## ADDENDUM THREE

Ivy Flats  
205 Rumely Street  
LaPorte, IN 46350

Commission No.: F22131

Addendum Date: 29 April 2024

**6** Storefront F  
1/4" = 1'-0"

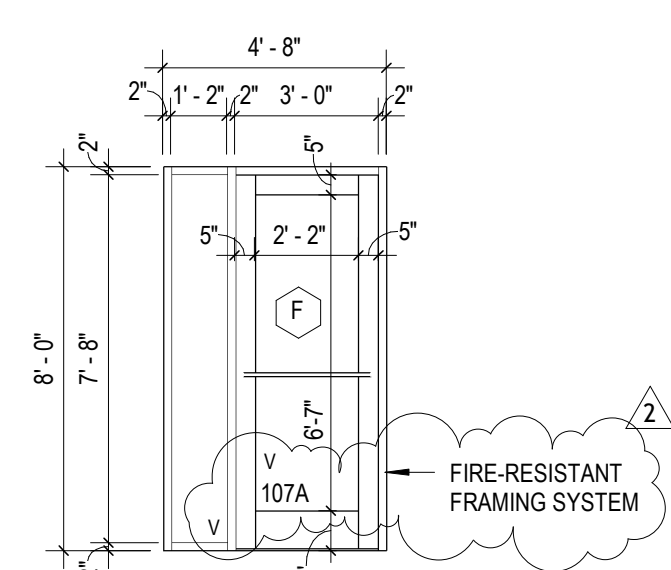
- **UPDATE** Glazing Type to 'FRG' (three panels, including door).
- 6/A512:
  - **ADD** Description Note stating, "FIRE RESISTANT FRAMING SYSTEM".
  - **UPDATE** Glazing Type to 'FRG' (two panels, including door).

**5** Storefront E  
1/4" = 1'-0"

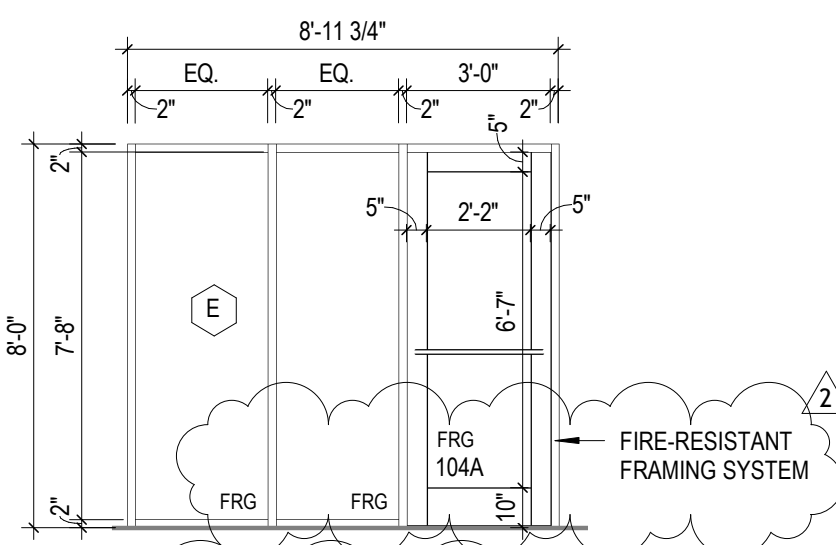
- GLAZING TYPES:
  - General Notes have been **REMOVED** from the schedule.
  - **ADD** 'FRG' Glazing Type into the Schedule.
- 5/A512:
  - **ADD** Description Note stating, "FIRE RESISTANT FRAMING SYSTEM".

# R103

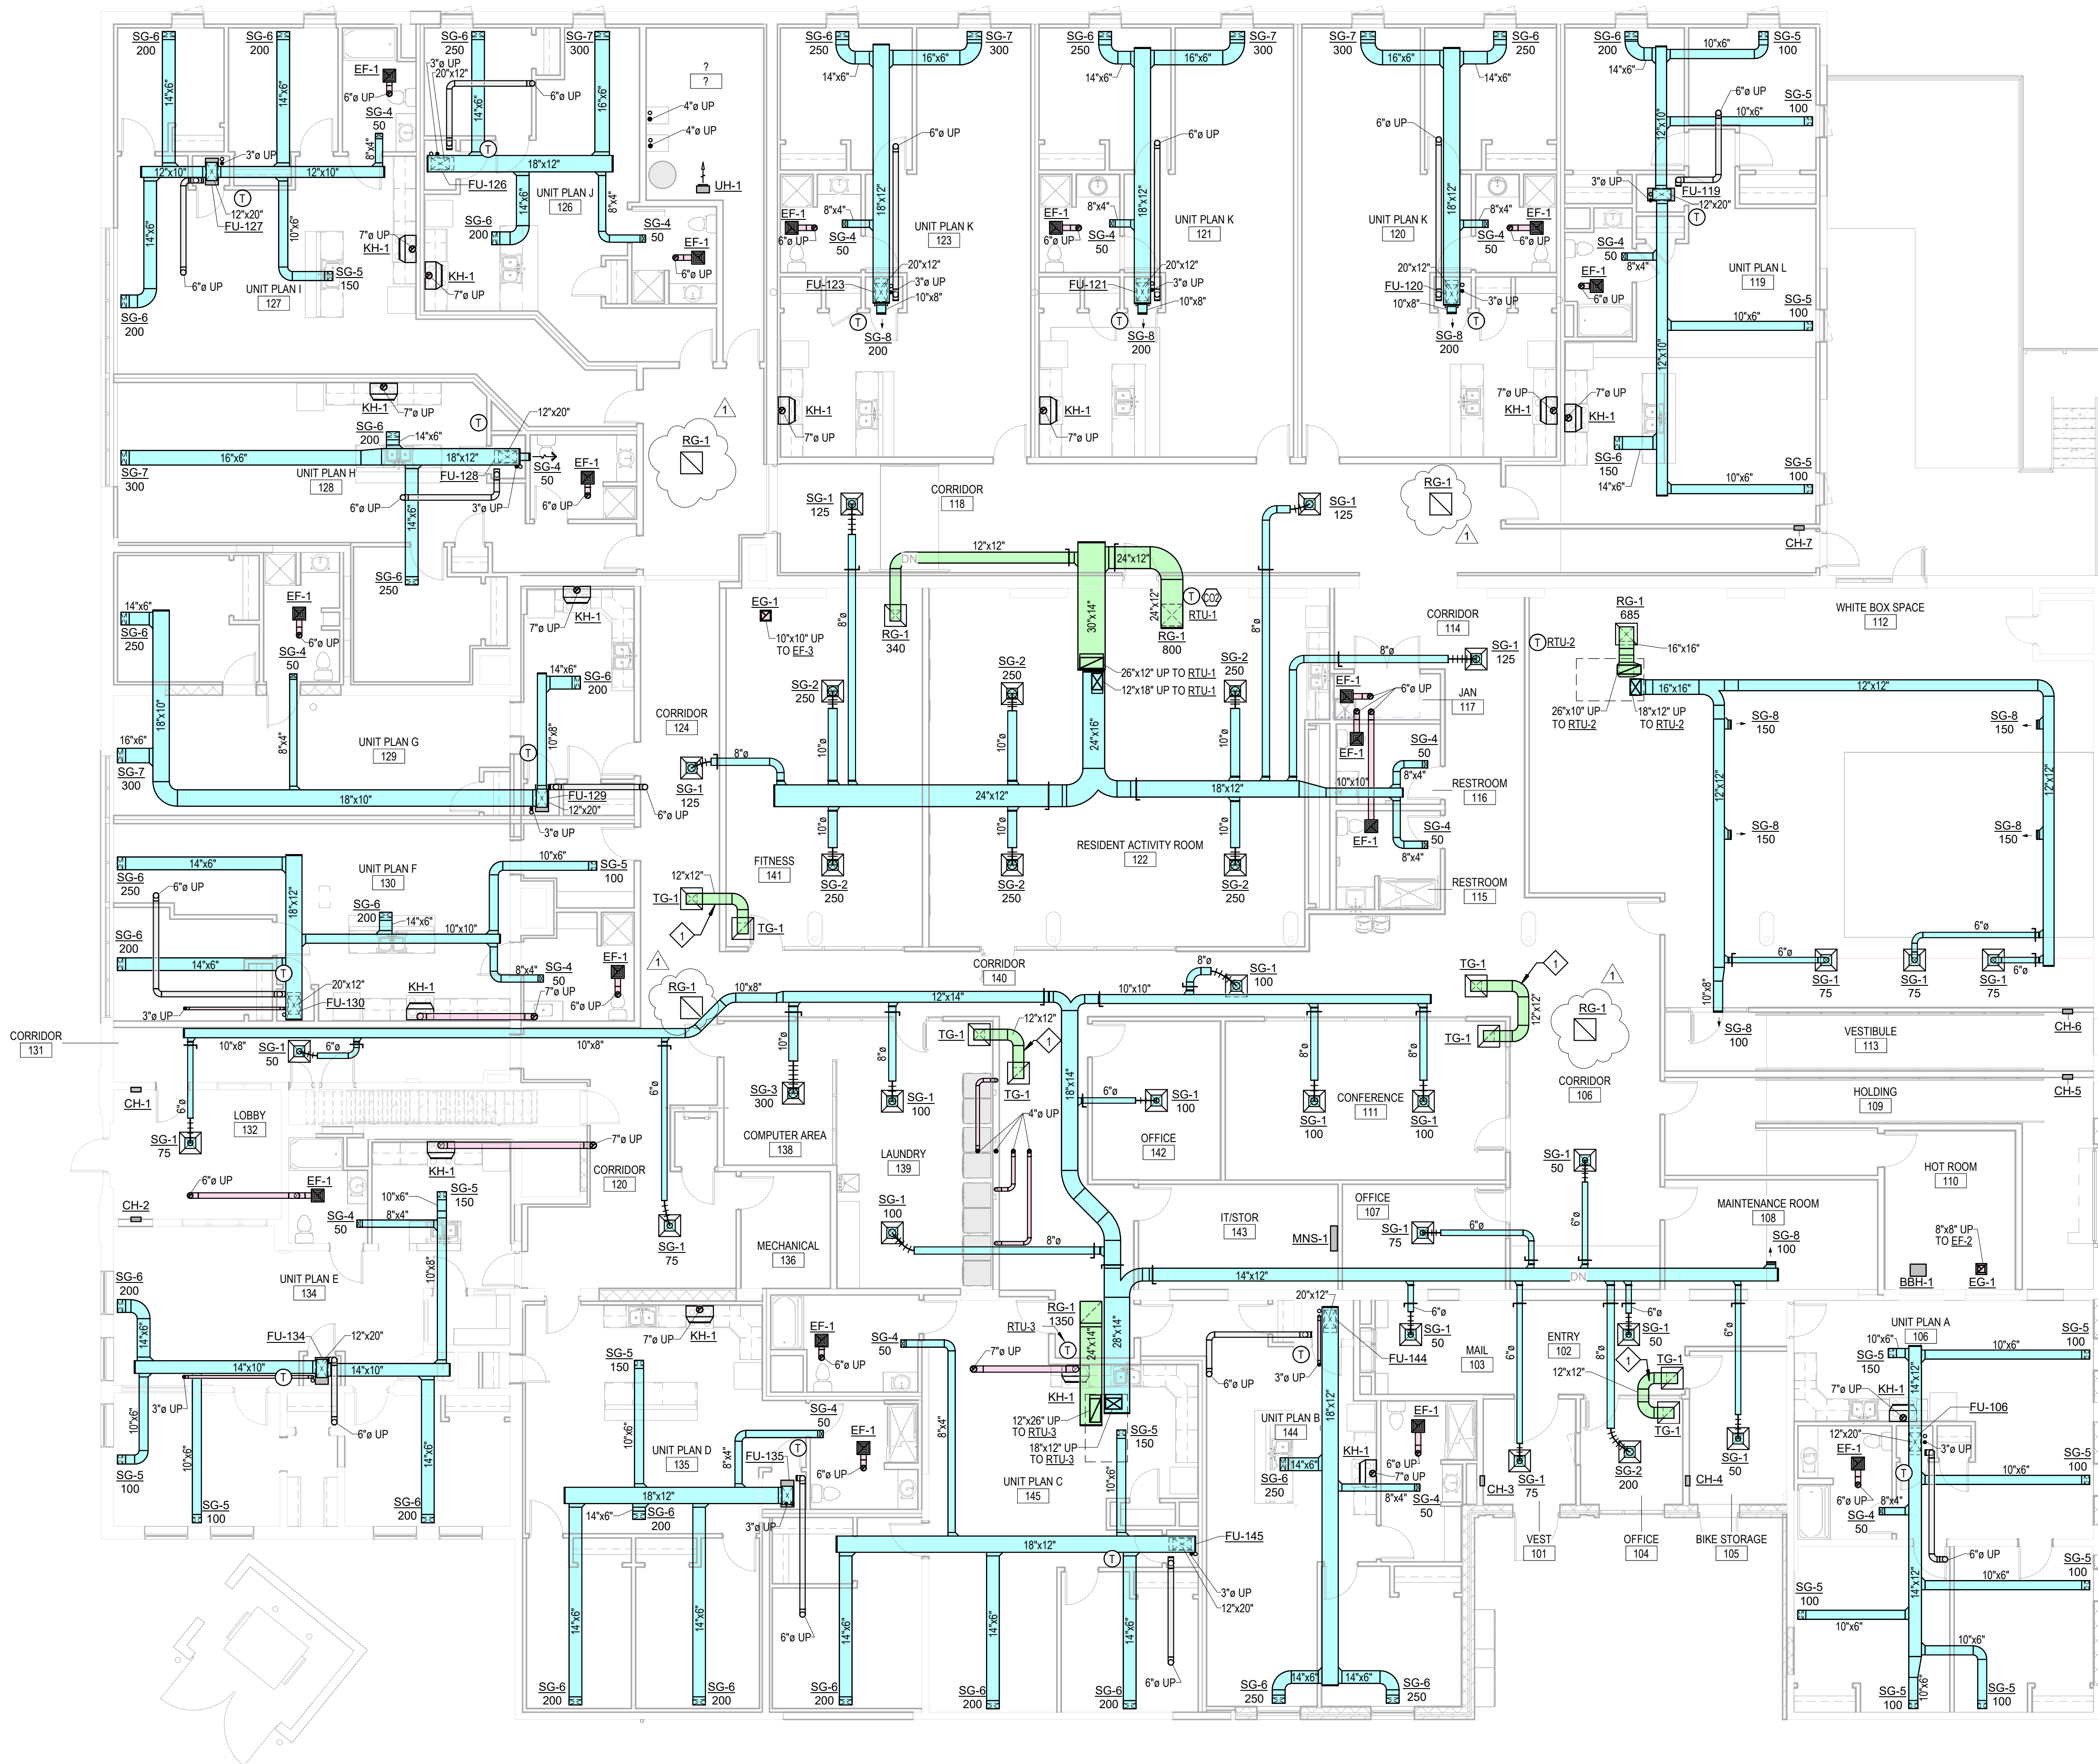
- 2/R103: Drawing **REISSUED**.
- **ADD** Detail 2.5/R103 Flue to Sheet.

# M101

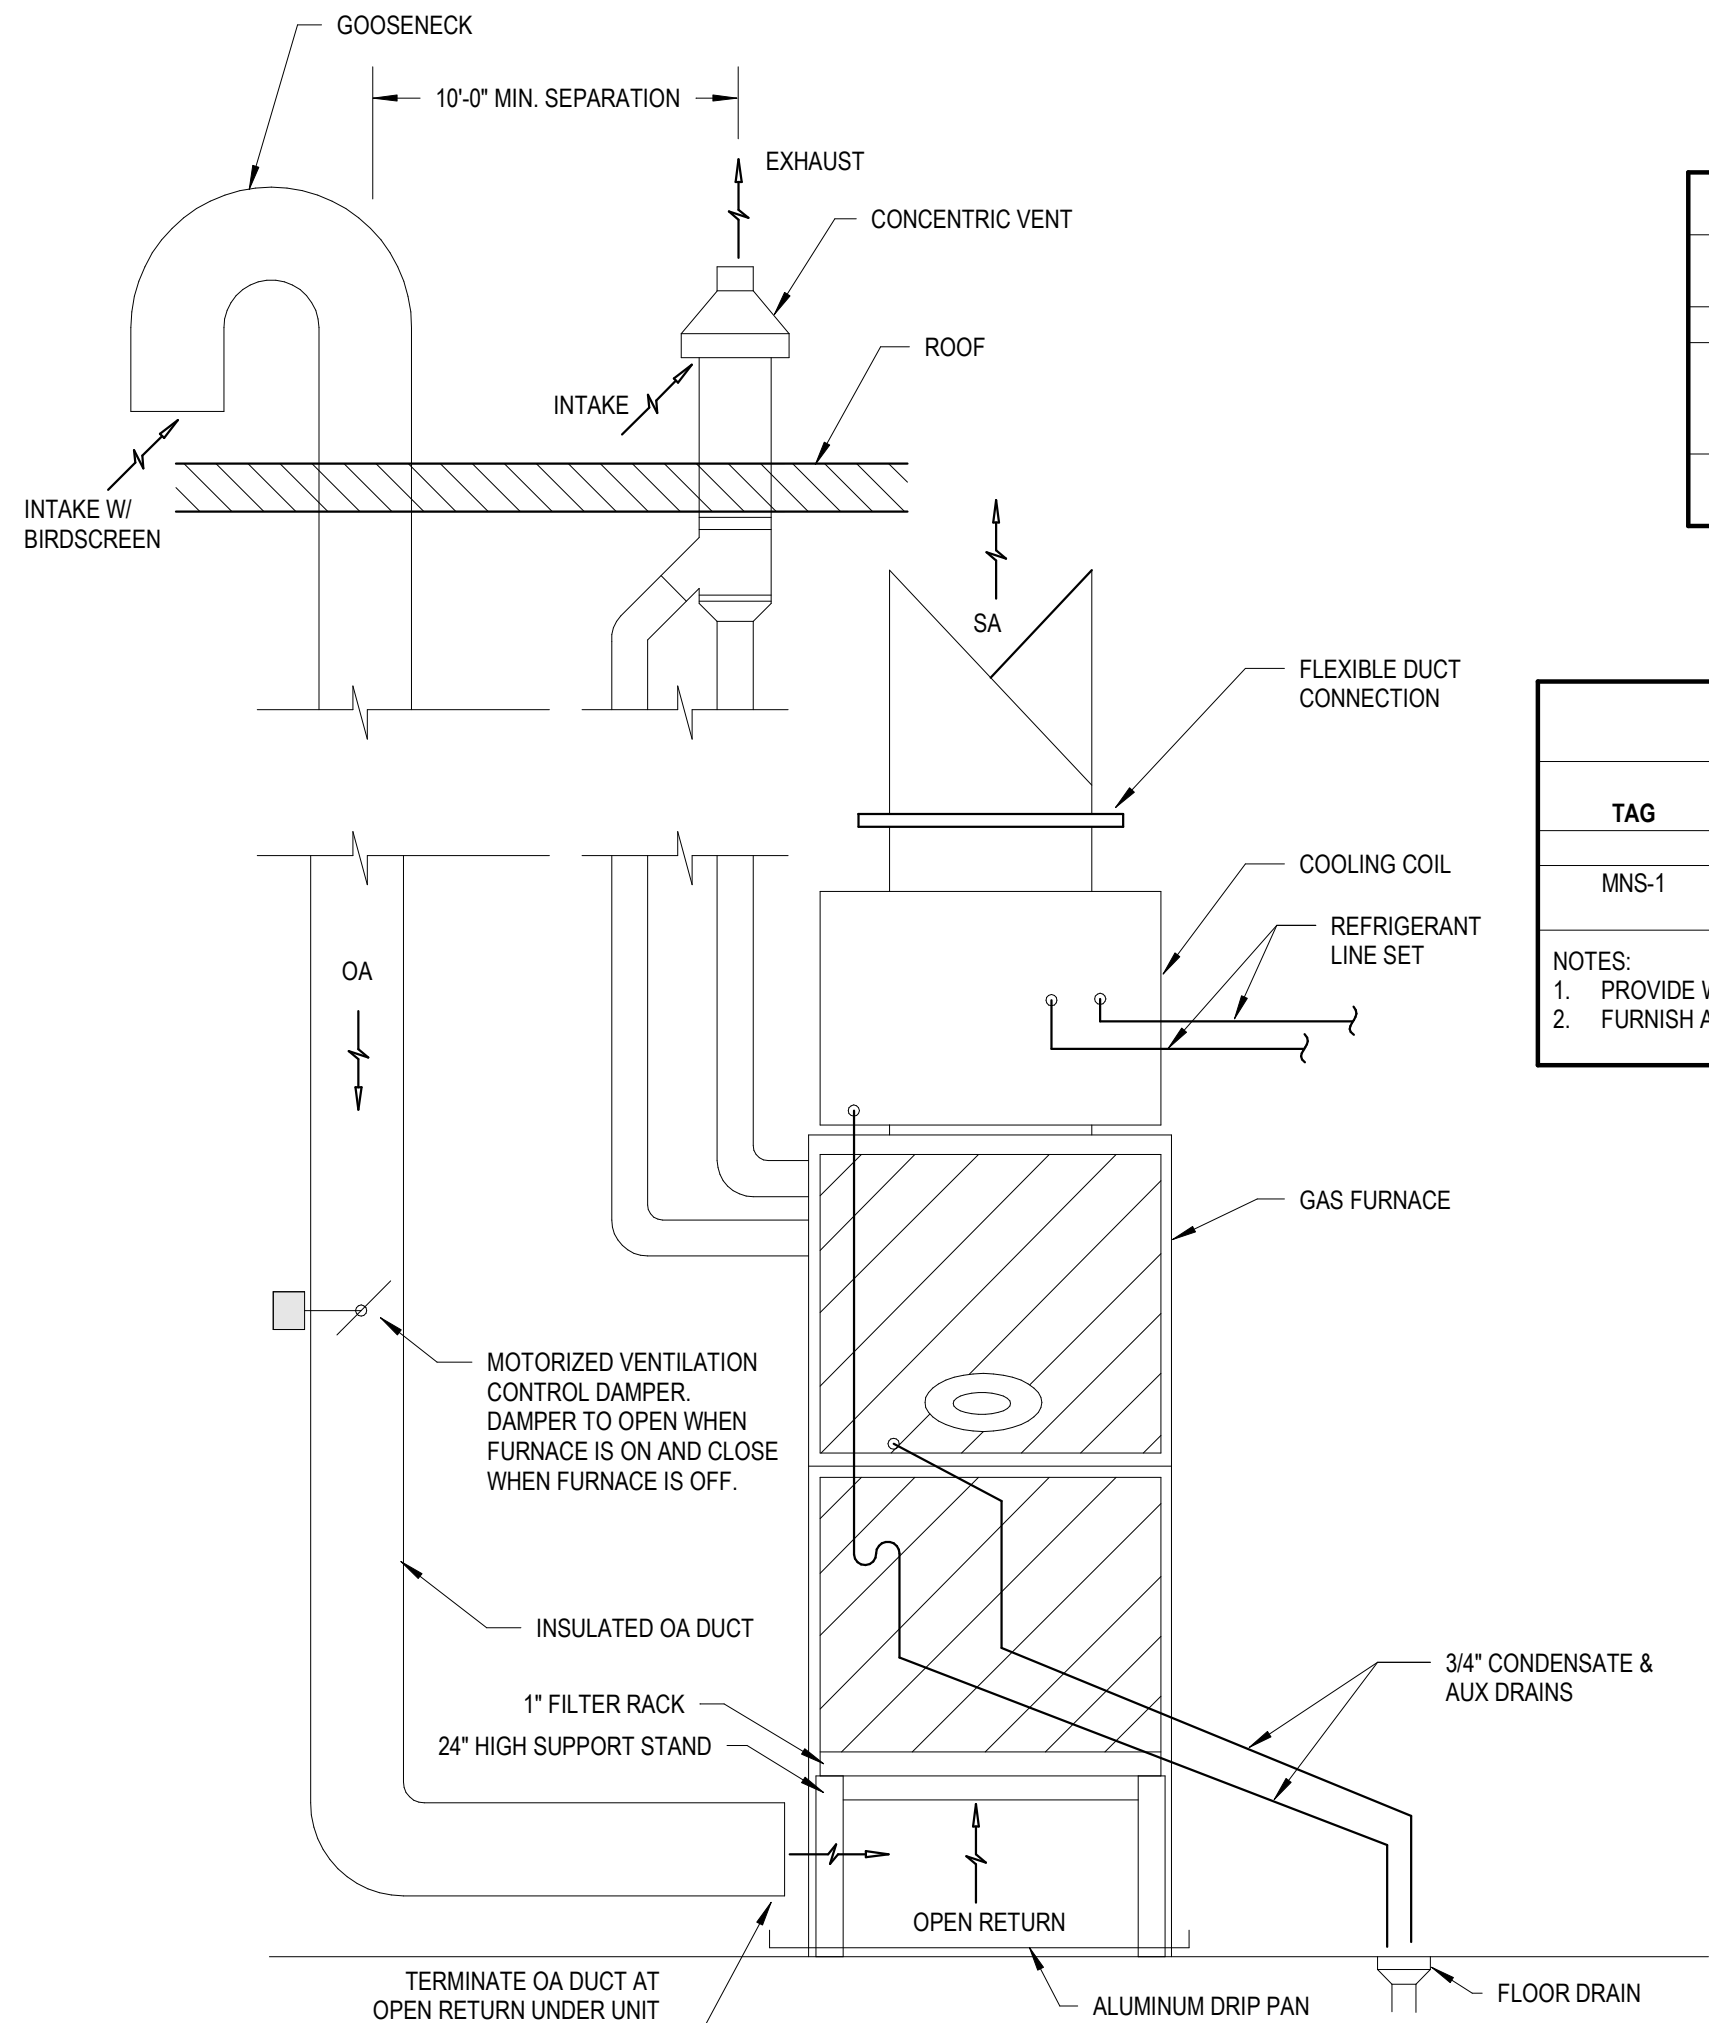
- 1/M101: (4) locations for return grills **ADDED** within the isometric.

**P101**

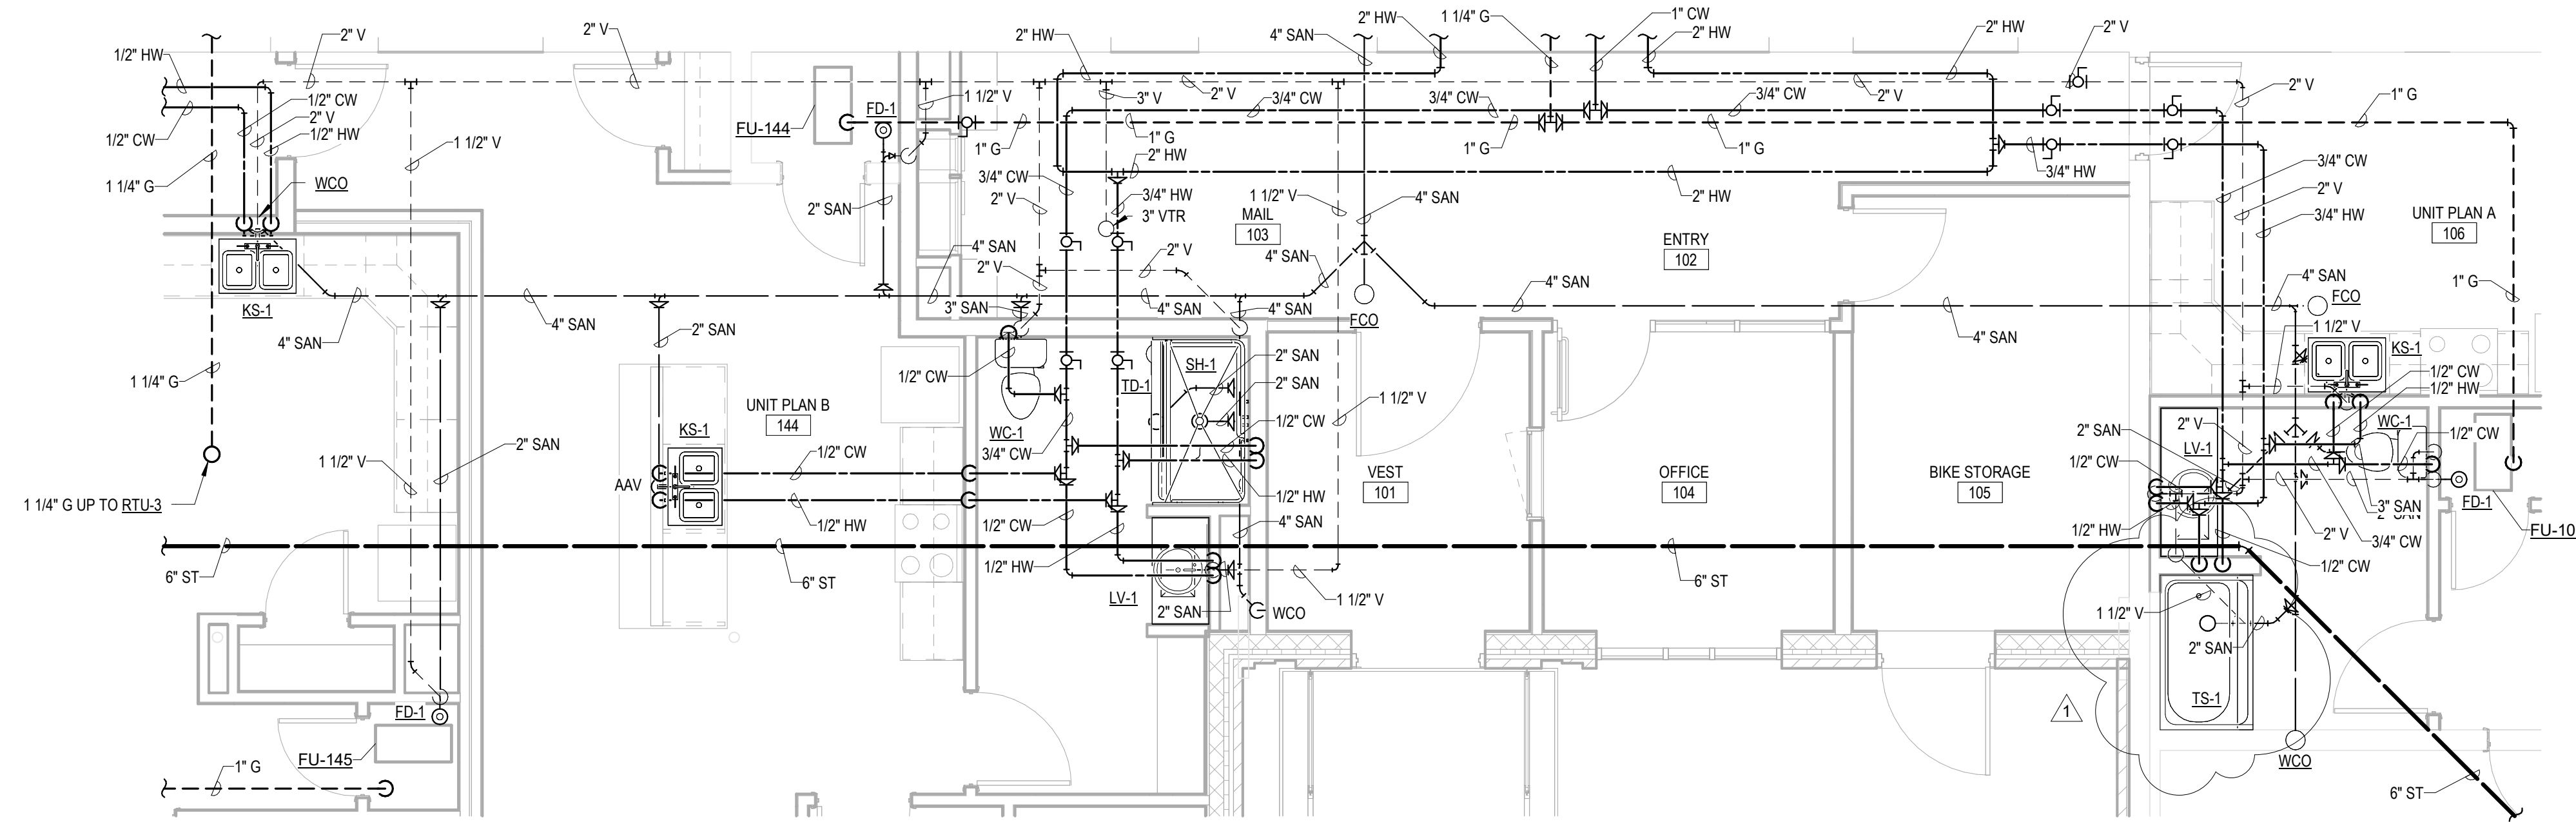
- 1/P101:
  - At Unit Plan A, Rm. 106, bathroom has been **RECONFIGURED** at the west wall to provide a tub enclosure in lieu of a roll-in shower.
  - At Unit Plan C, Rm. 145, roll-in shower has been **REPLACED** with tub enclosure in lieu of a roll-in shower.
